PIP2 IT Beam Pattern Generator Drive Amplifier *Design Changes*

J. Dusatko / FNAL-AD-RF-LLRF
September 14, 2020

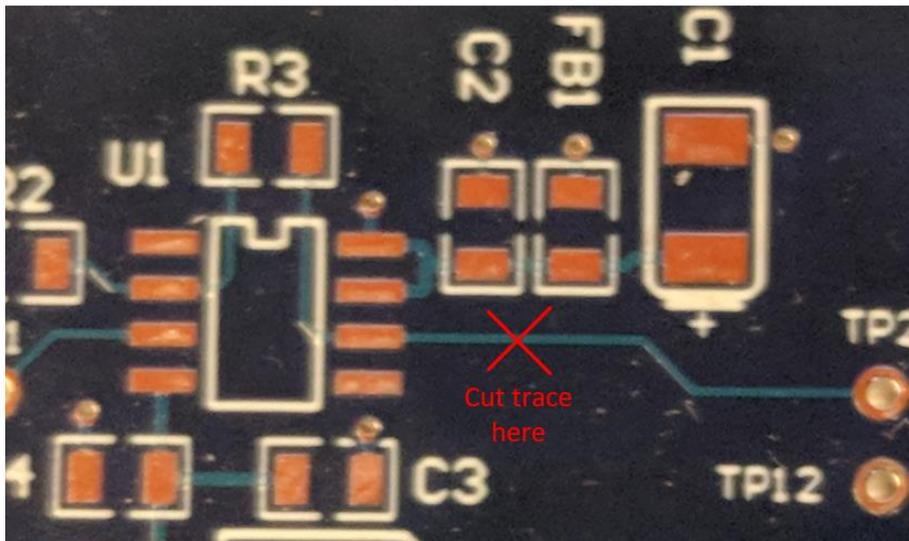
Reference Designator	Value	Comment
R9	0 ohms	Was originally Do Not Install
R1000	30 ohms	Rework: add 0805, 30 ohm resistor to U1-6: place close to U1-6, cut trace & remove solder mask. Solder resistor onto exposed trace copper across the cut section of trace

Preamp series output resistor addition:

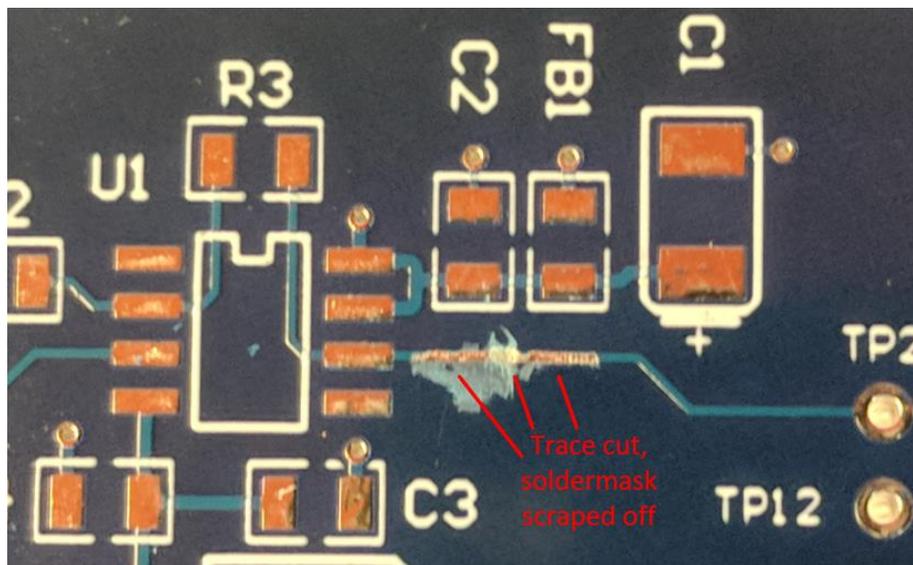
- 1) Locate U1-6
- 2) Using a xacto-knife, make a small cut in the trace in two places and remove the copper between the cuts (the amount removed should be less than the width of the 0805 resistor). Do not cut too deeply (don't want to short the power plane).

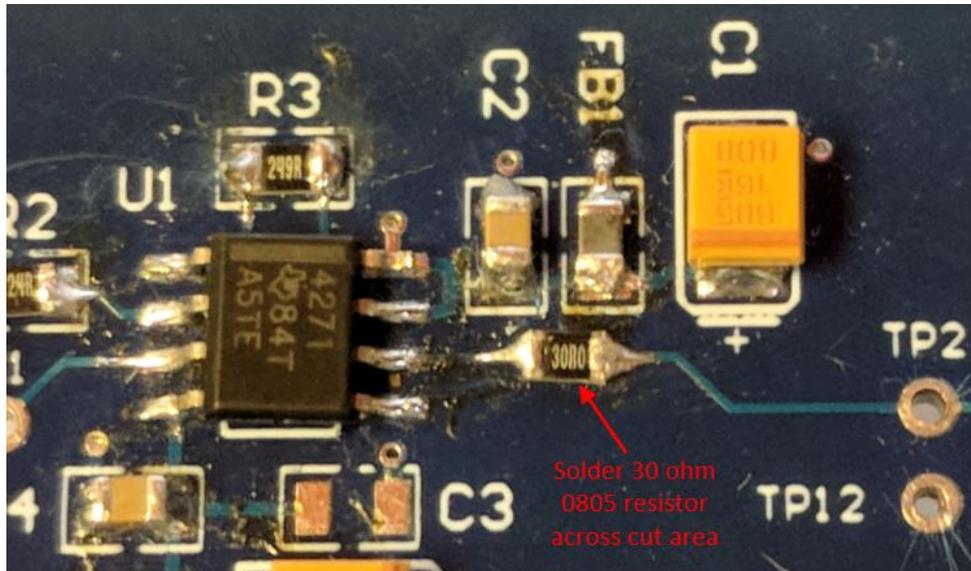
- 3) Scrape off the solder mask on the PCB trace before and after the cut.

- 4) Place a 30 ohm, 0805 resistor (R1000) onto the exposed copper on the traces (it should sit over the cut) and solder in.

THS4171 & EL5166 OPAMP Rework:

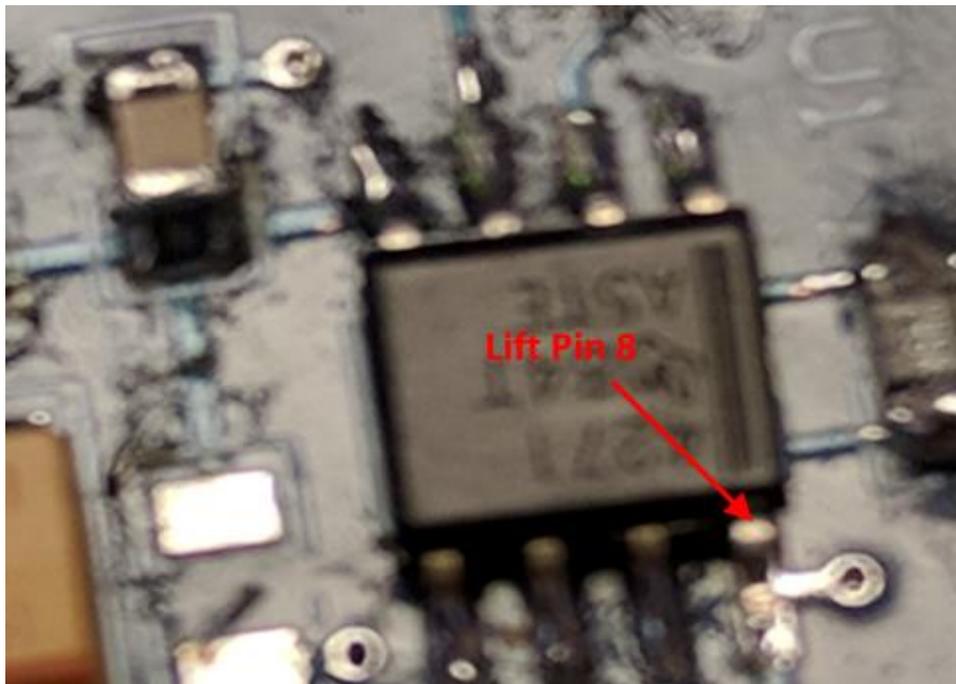
- 1) When installing U1 (THS4271), lift pin 8 (should NOT be soldered down to pin 8 pad)
- 2) When installing U4 (EL5166), lift pin 8 (should NOT be soldered down to pin 8 pad)

(Example on U1)
